SOLICITATION AMENDMENT MODIFICATION DE L'INVITATION

Title - Sujet 191 Laurier Street, Furniture Categ	
Solicitation No. - N° de l'invitation EP076-201692/A	Amendment No. - N° modif. 002
Client Reference No. - N° de référence du client 20201692	Date 2019-11-22
GETS Reference No. - N° de référence de SEAG PW-\$\$PQ-991-77966	
File No. - N° de dossier pq991.EP076-201692	CCC No./N° CCC - FMS No./N° VME
Solicitation Closes - L'invitation prend fin at - à 02:00 PM on - le 2019-11-29	
Time Zone Fuseau horaire Eastern Standard Time EST	
F.O.B. - F.A.B. Plant-Usine: <input type="checkbox"/> Destination: <input type="checkbox"/> Other-Autre: <input type="checkbox"/>	
Address Enquiries to: - Adresser toutes questions à: Ouimet, Daphné	Buyer Id - Id de l'acheteur pq991
Telephone No. - N° de téléphone (343) 551-0104 ()	FAX No. - N° de FAX () -
Destination - of Goods, Services, and Construction: Destination - des biens, services et construction: See Herein

Amendment 002 is raised to extend the bid closing date, to replace Table 1 – Product Table for Category 1A, 1B and 2 from the request for proposal and to answer questions received from industry as follows:

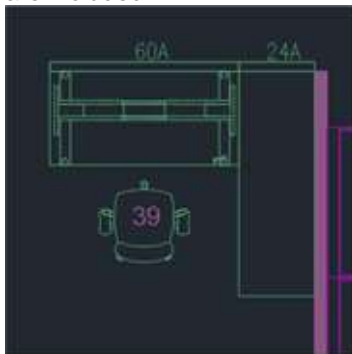
Question 3

The workstation below does not show panels behind the fixed worksurface. Please confirm no panels are included

The pink line is the wall. The panels are to be wall mounted, so there is no panel included on that side of the worksurface.
